File: Homestead Bay
Your ref: FTAA-2506-1071

Response to Further Information Requested by the Homestead Bay Expert Panel under s 67 Fast-track Approvals Act 2024

Graph 1: New Dwelling Building Consents Approved between 2015- 2024 - Jacks Point and Queenstown – Source Statistics NZ

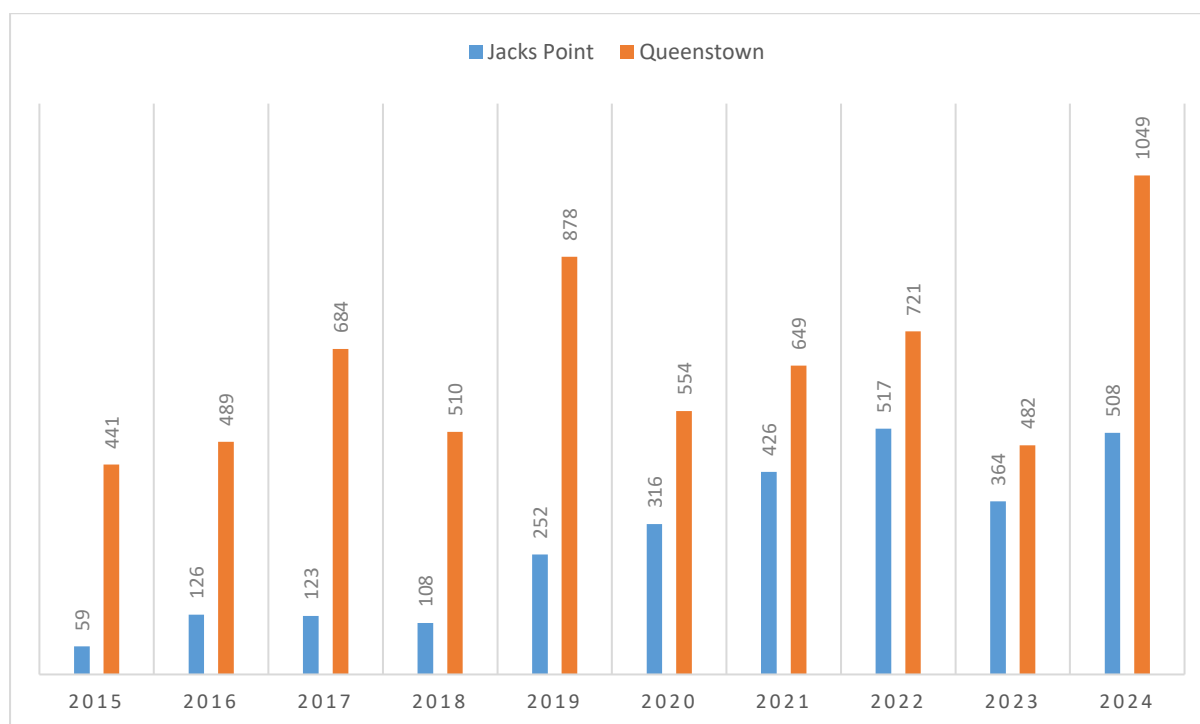
7. Graph 1¹ outlines the number of consents approved in Jacks Point² and Queenstown. Jacks Point includes the development known as Hanley's Farm (developed by the applicant for this Fast Track Consent application) and is now nearing completion. The graph shows that:

- Queenstown has had between 441 and 1049 building consents approved annually, averaging approximately 650 per year over this period.
 - Jacks Point has had between 59 and 508 new dwelling building consents approved annually, averaging approximately 280 per year.

- From 2015 to 2019 and in 2024, Queenstown had a least one to two other developments providing competition to Jacks Point (notably Shotover Country and Frankton). When development in Shotover Country reduced as development was nearing completion, competition slowed in Queenstown, leaving Jacks Point as the only large development area. In 2024, while consents remained high in Jacks Point, a development in Frankton provided 254 new dwelling building consents (the highest number of building consents approved in Queenstown over the past decade).

Graph 2: Proportion of new dwelling building consents issued in Jack Points compared to Queenstown
Source: Statistics NZ

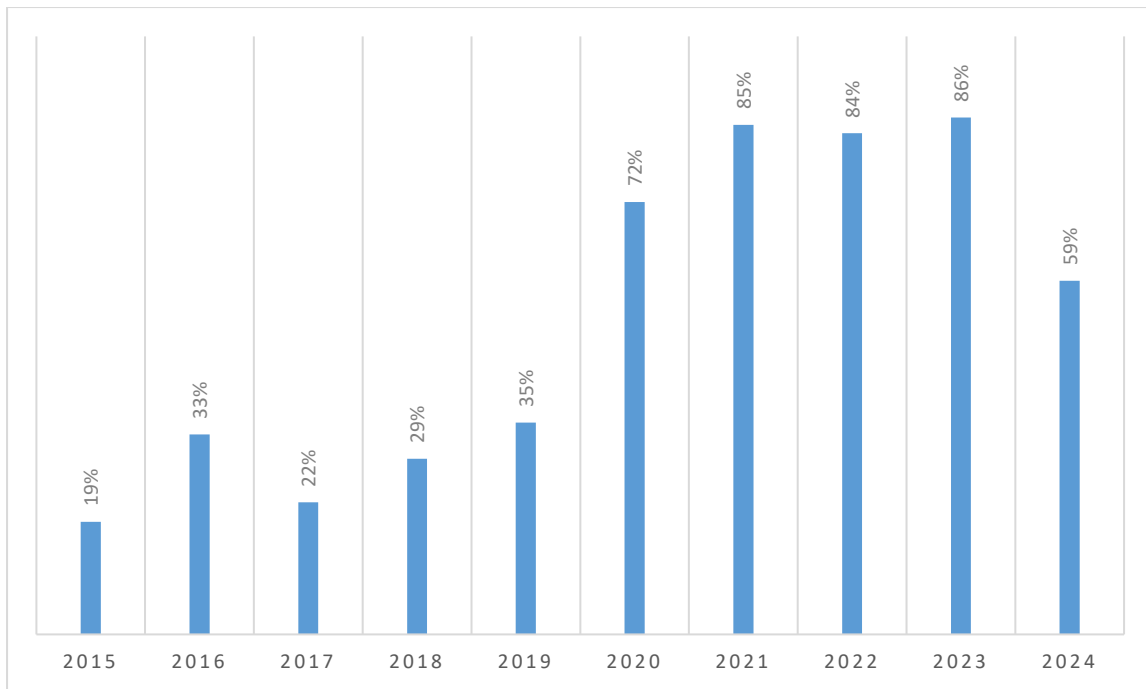
8. Graph 2 illustrates the proportion of new dwelling building consents in Jacks Points compared to the total consents issued in Queenstown, reinforcing the observations noted above. When there is increased competition in the market, the opportunities for development to be concentrated in a single area are reduced.
